Subject: **SBWR Test Program**

Reference: Purdue Testing Meeting, GIRAFFE Testing Program RAIs,
October 1, 1993

Requests for Information by Purdue University prior to
meeting on October 1, 1993.

GE ANSWERS TO PURDUE UNIVERSITY QUESTIONS ON SBWR SYSTEMS

Question 1b
Response

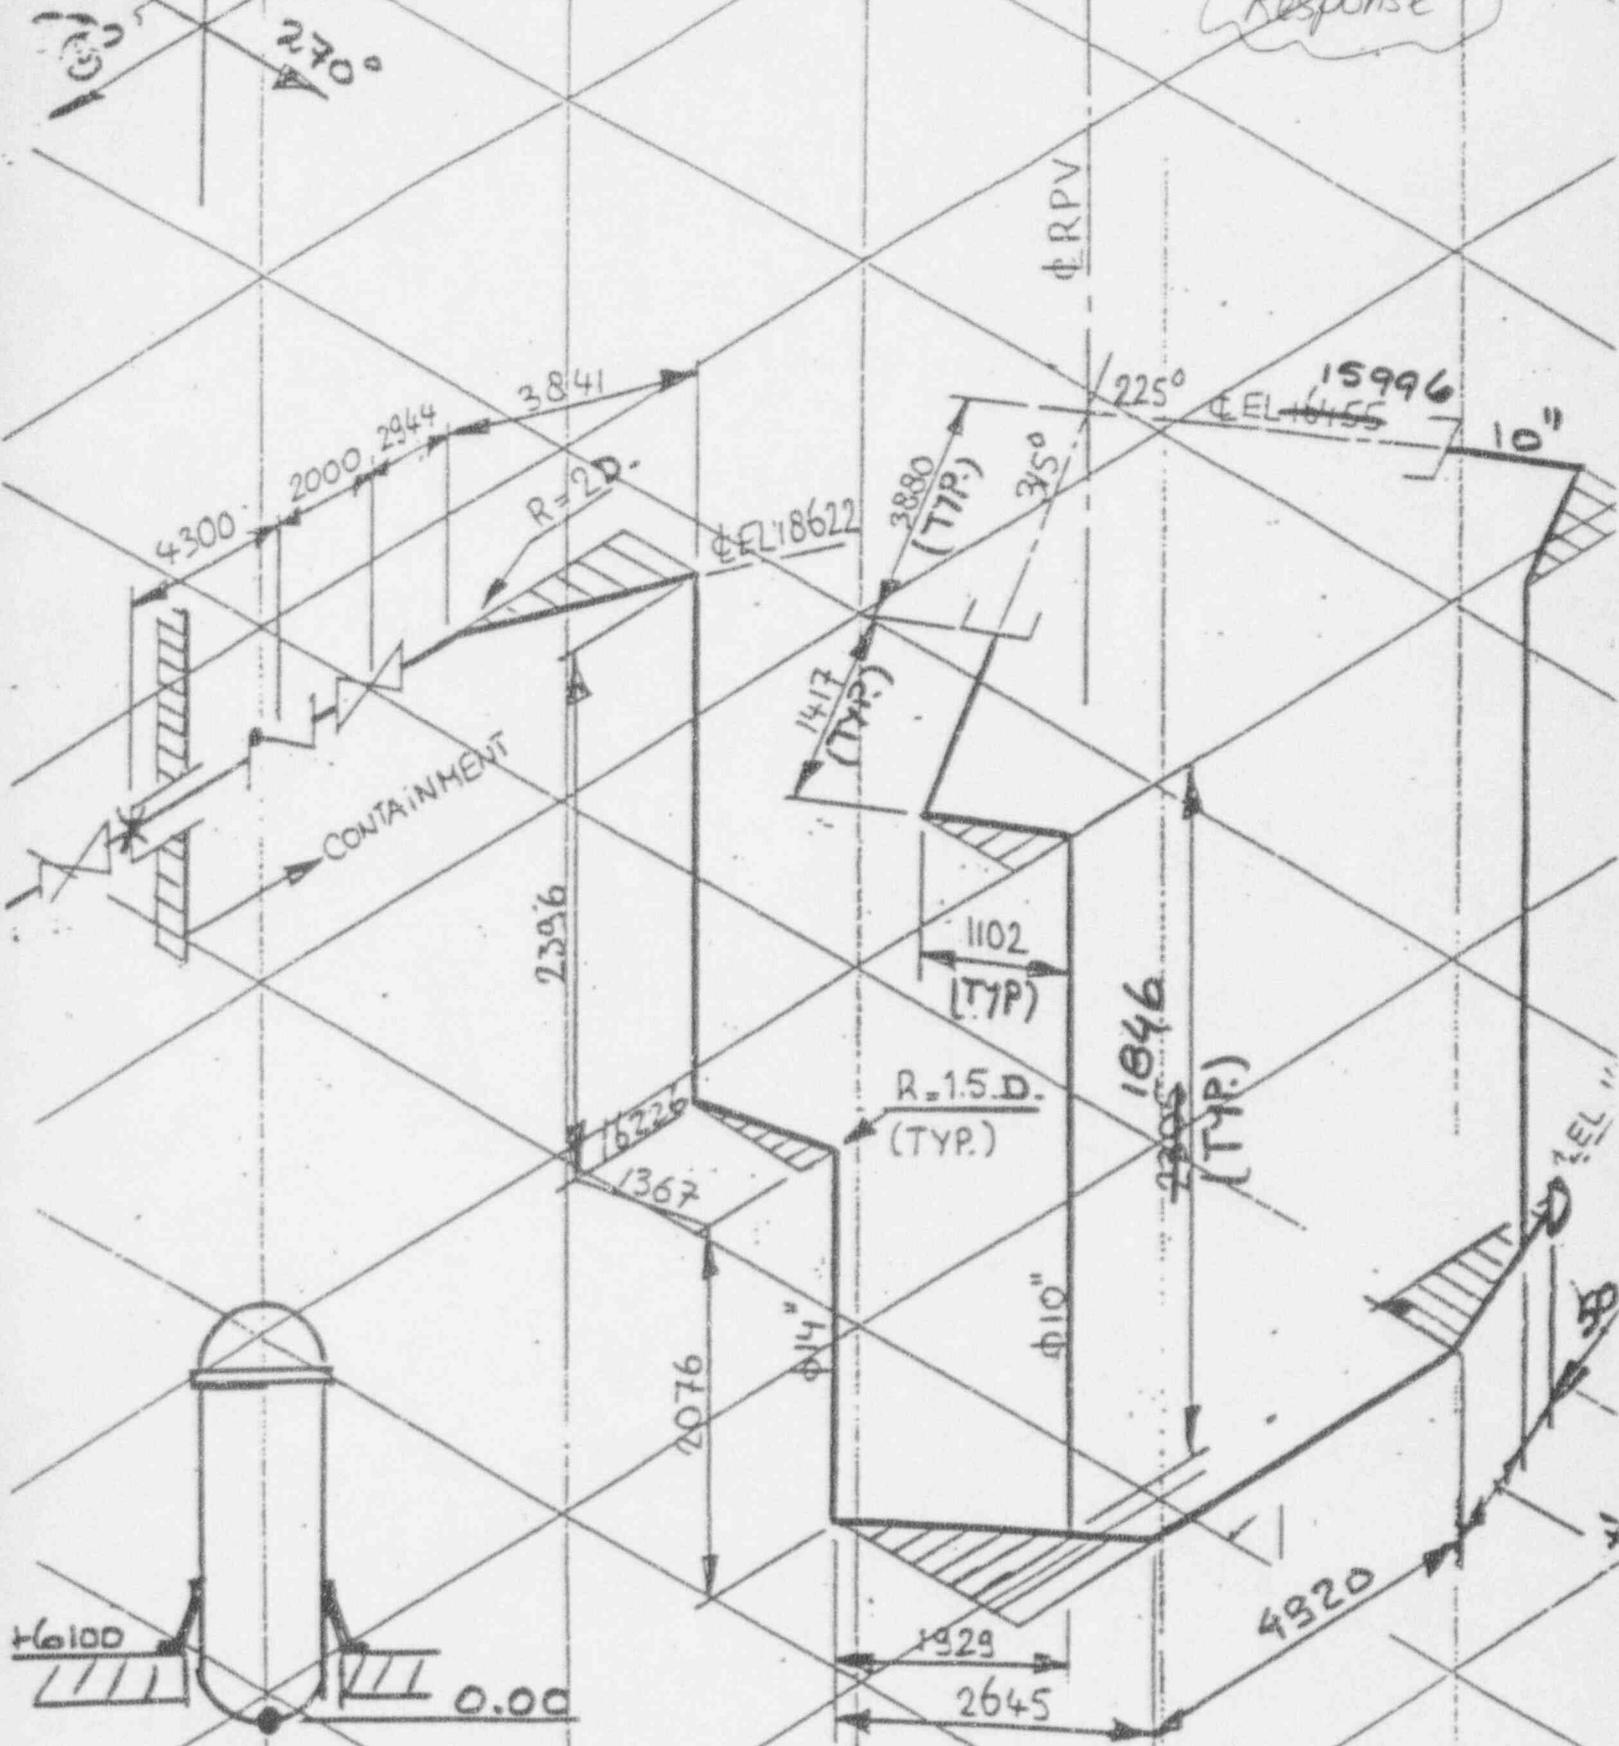
- b. Isometric drawing of the Feedwater supply line is needed to know the elevation difference etc. in case of break.
 - c. What action is taken with feedwater supply line during a LOCA? Which valves are closed (There is one manual valve, three check valves and one motor operated valve on each line. Which of these are closed during LOCA)? See attached Table 3.1 in SBWR Response to Loss of Feed Water. At Level 2, what actions are taken?

- b. Isometric drawing of Feedwater Supply line (inside containment) is attached.

Question 1a
Response

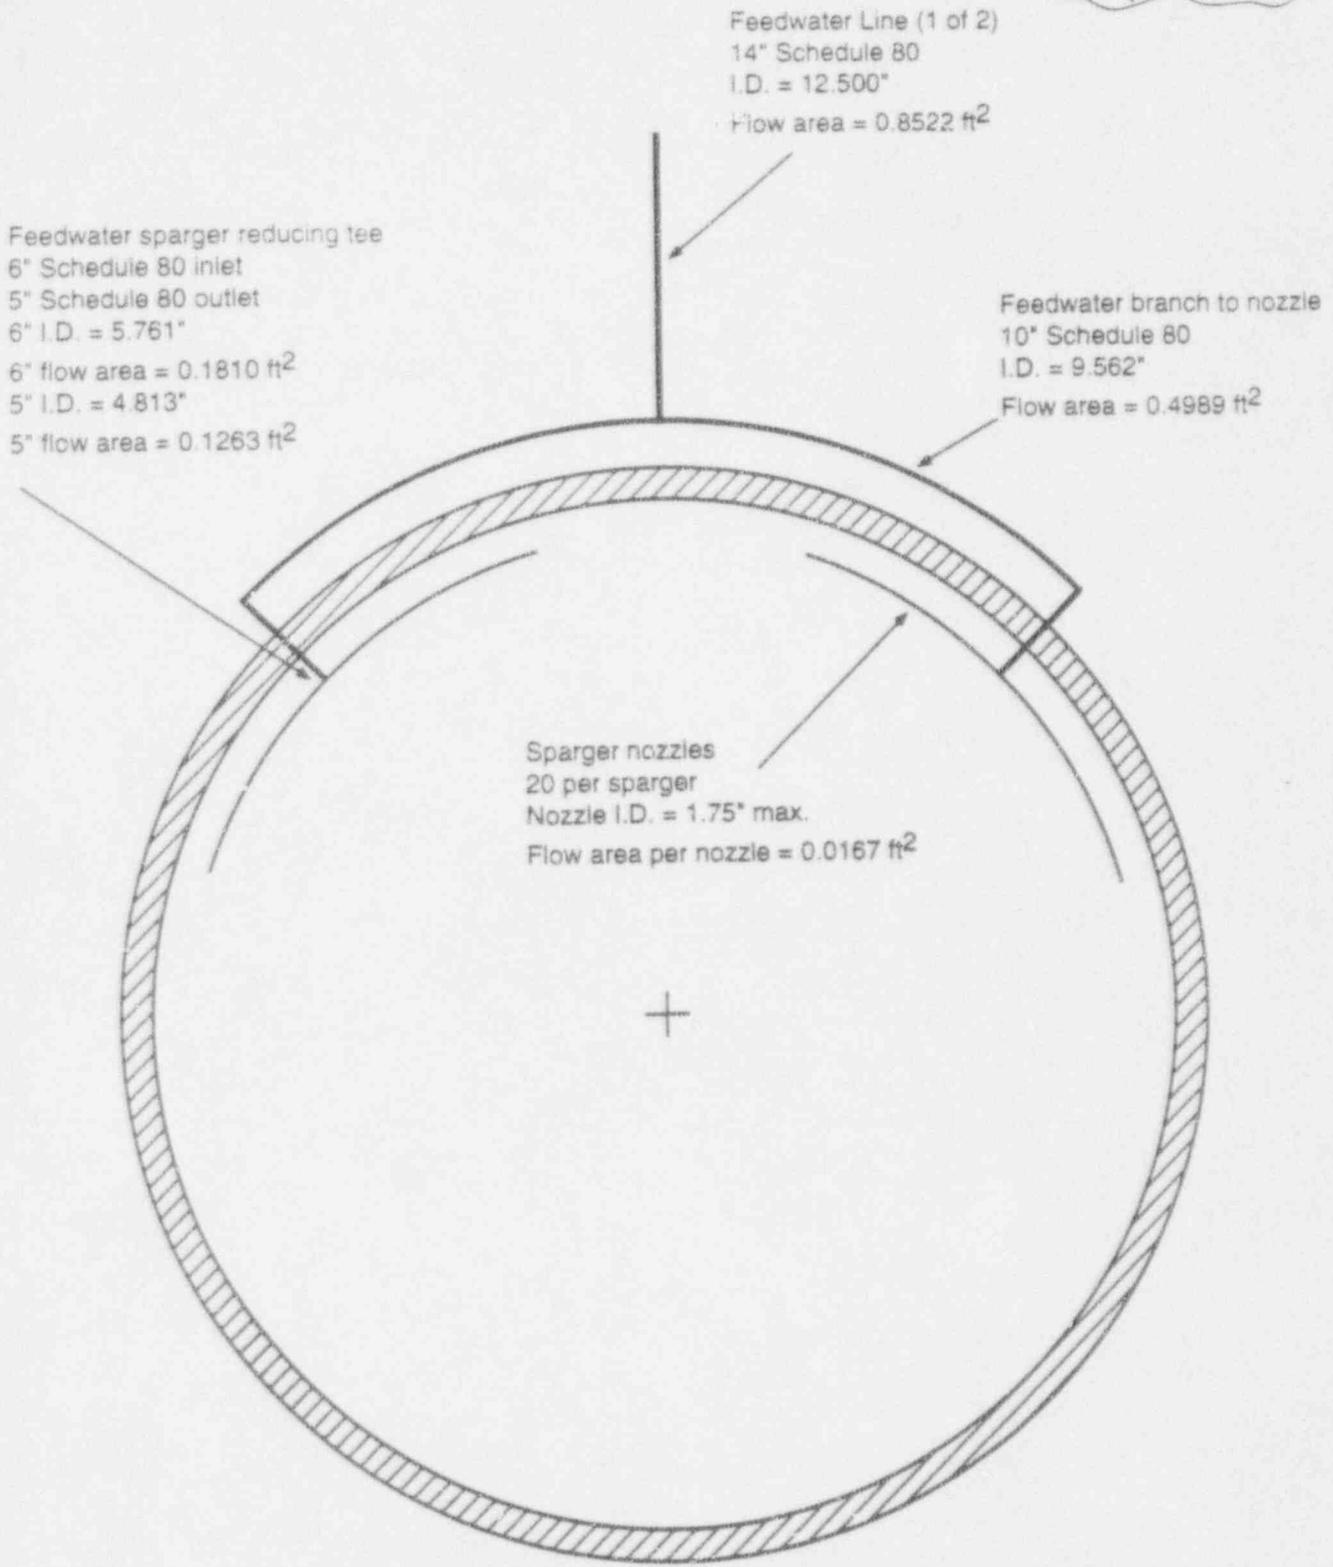
1. Feed Water Line
 - a. During a feedwater line break the flow will be choked/restricted by the area of the sparger. Therefore we need detailed design of the sparger.

- a. During a feedwater line break, the flow will be choked/restricted at the sparger inlet as shown in the figure.

Detail sparger dimensions given in figure.

Feedwater Line Break Area Calculation

14" feedwater line	1 line	0.852 ft ²
10" feedwater branch to nozzle	2 lines	1.00 ft ²
6" Tee inlet	2 lines	0.362 ft ²
5" Tee outlet	4 lines	0.504 ft ²
Sparger nozzles	40 total	0.668 ft ²

Conclusion - **Limiting break area = 0.362 ft²**

GDCS
 Figure 4.3.3-2. Check Valve Minimum Required Flow Coefficient
 (English Units)

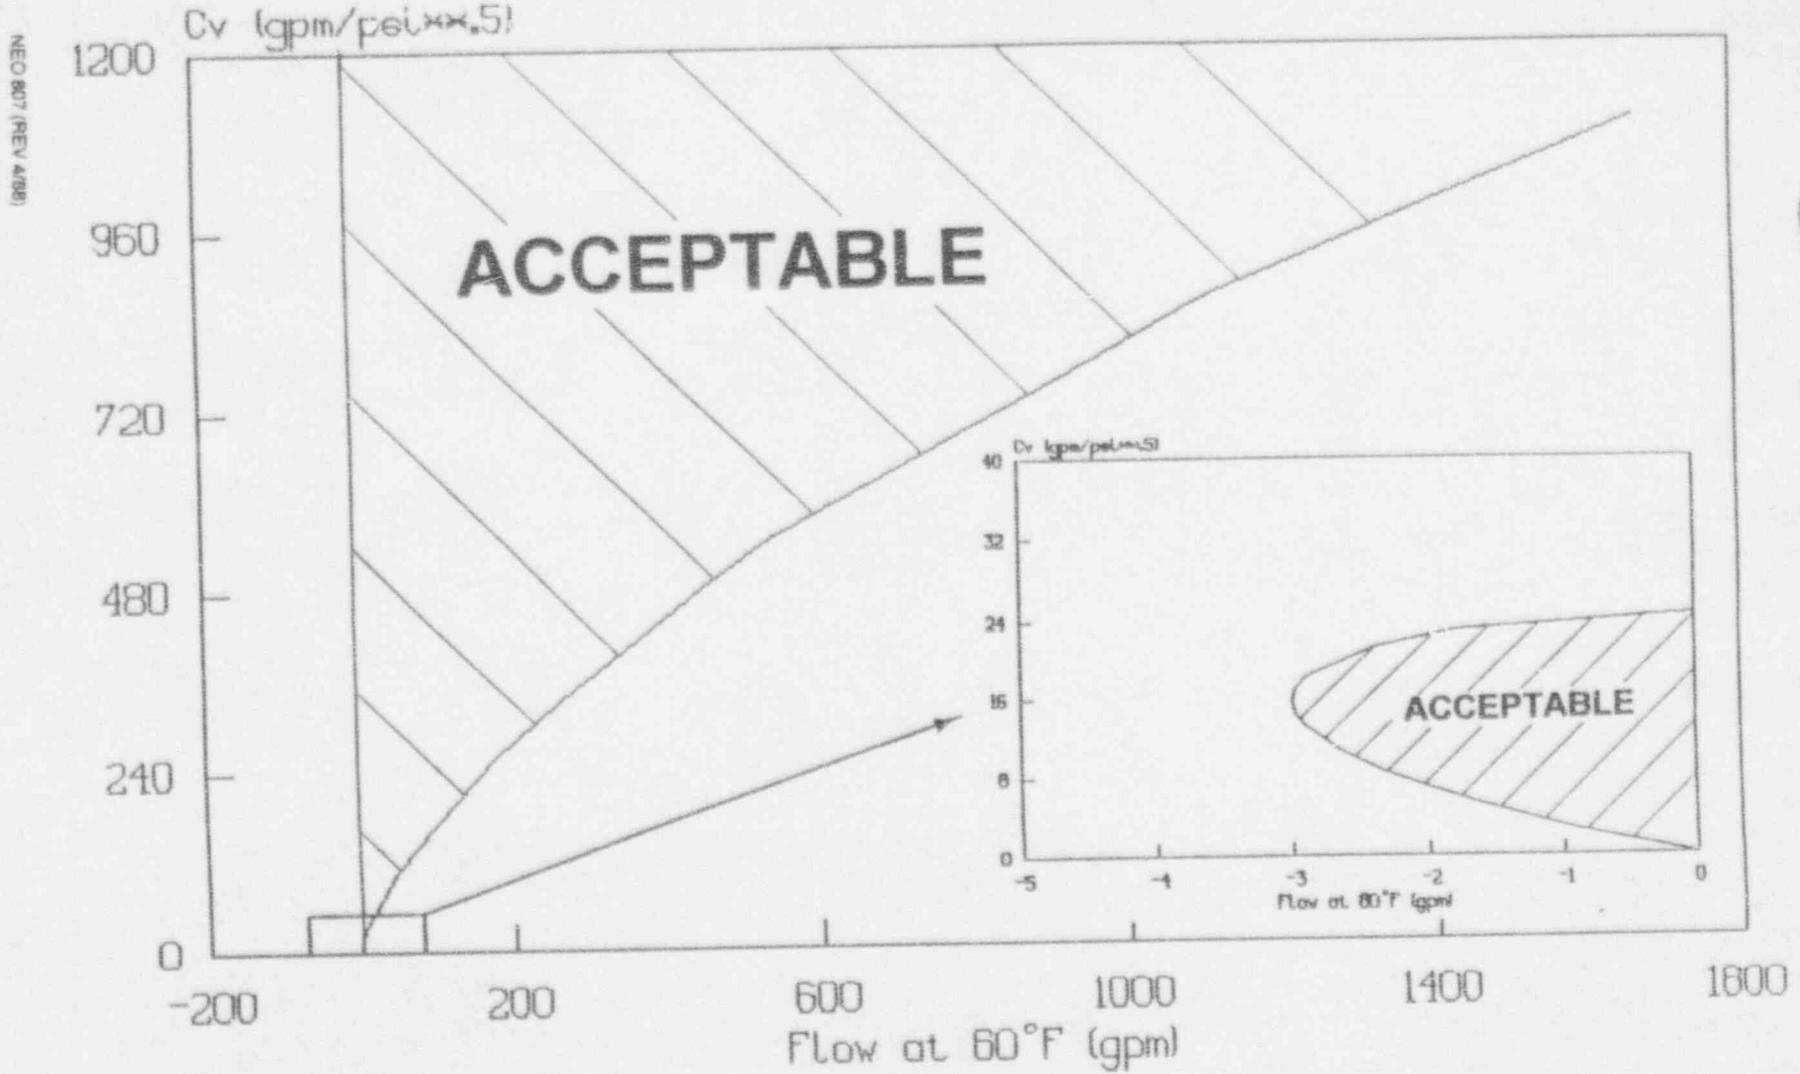
2. Provide detailed information on the loss coefficients for all the lines. In particular give the minor loss coefficients of all the valves in the following lines:

Response to Question 2 for GDCS

(Response to Question 3b)

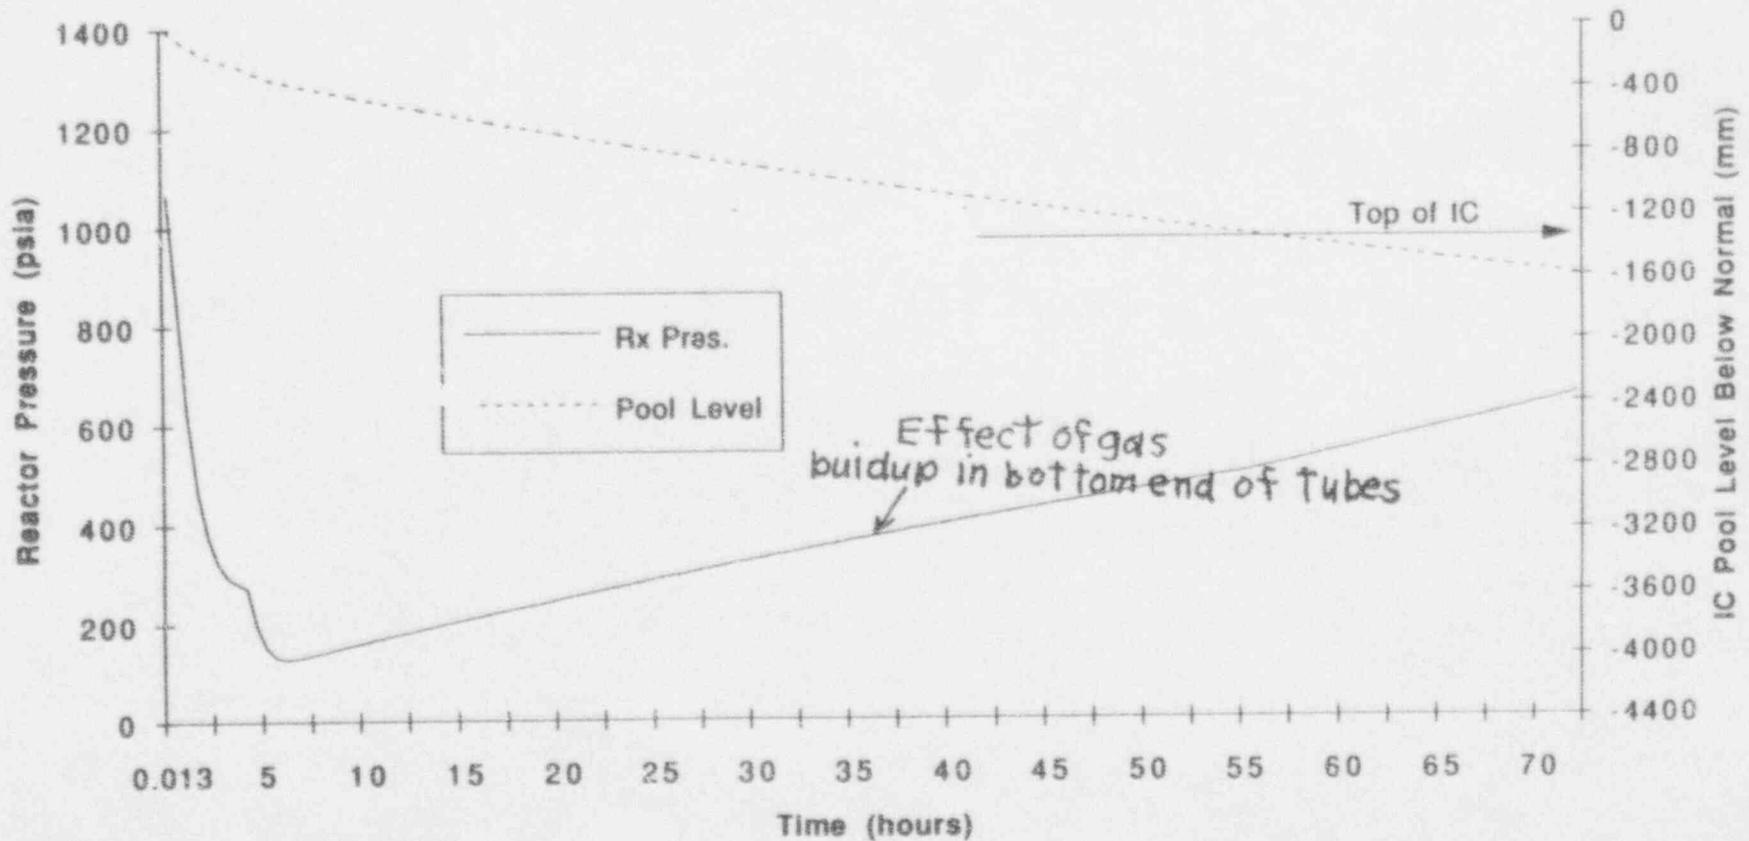
- b. IC pool water level depletion as a function of time (up to 3 days). Can we reduce the volume?

- b. IC pool water depletion as a function of time is shown in attached figure.

Can volume be reduced? Yes, as shown in the figure.

Figure 5.3-3 Reactor Pressure Vessel System Key Features

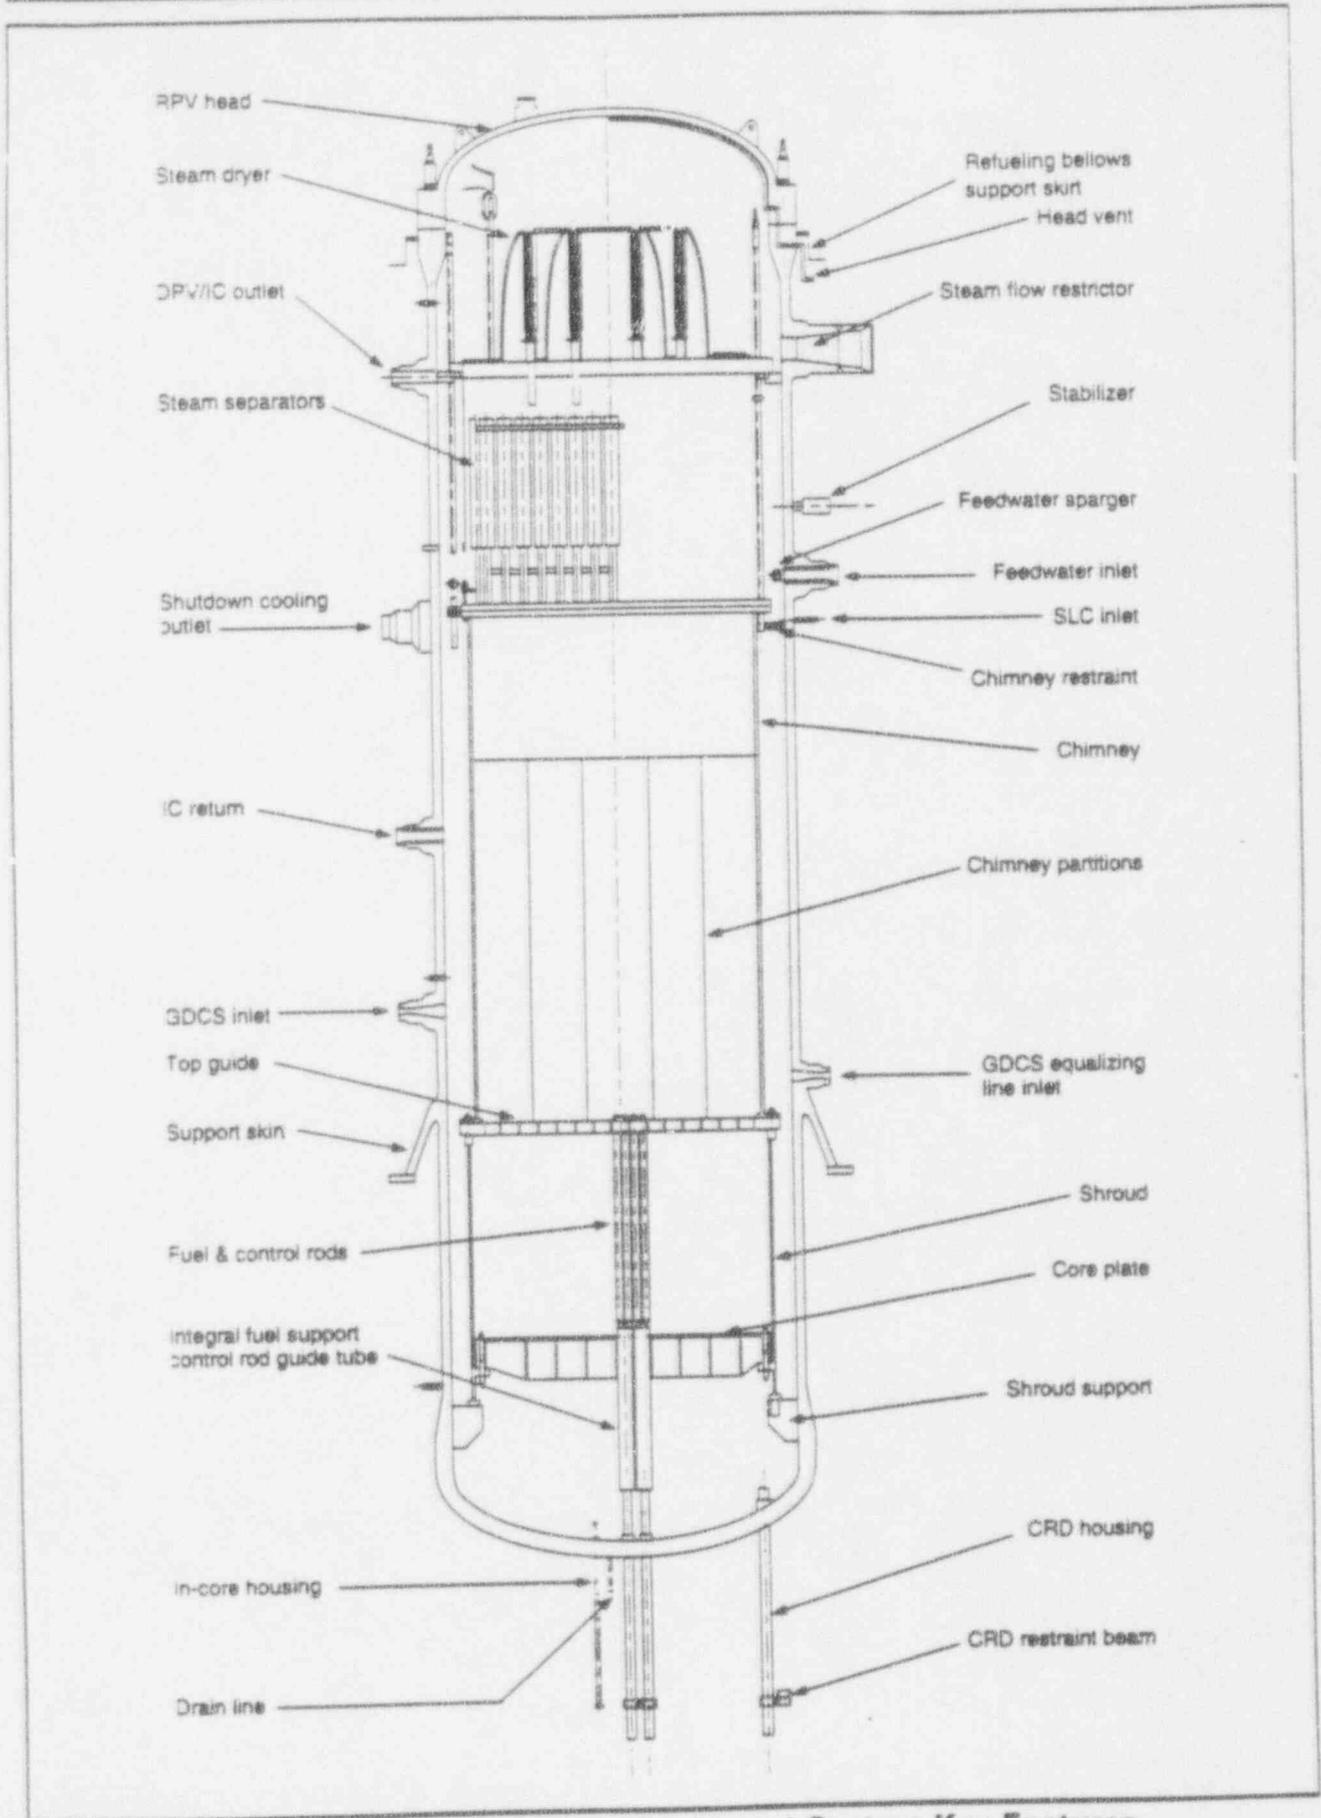
- b. What is the loss coefficient across the steam separators?
 - c. Explain the pressure drop data across the lower plenum and the core plate. K values of the core inlet flow restrictors (orifice K values) is needed.

- b. Steam separator loss coefficients: Given in attached response to NRC Questions

- c. Pressure drop data across the lower plenum and the core plate, K values of the core inlet flow restrictors:

Given in attached response to NRC questions.
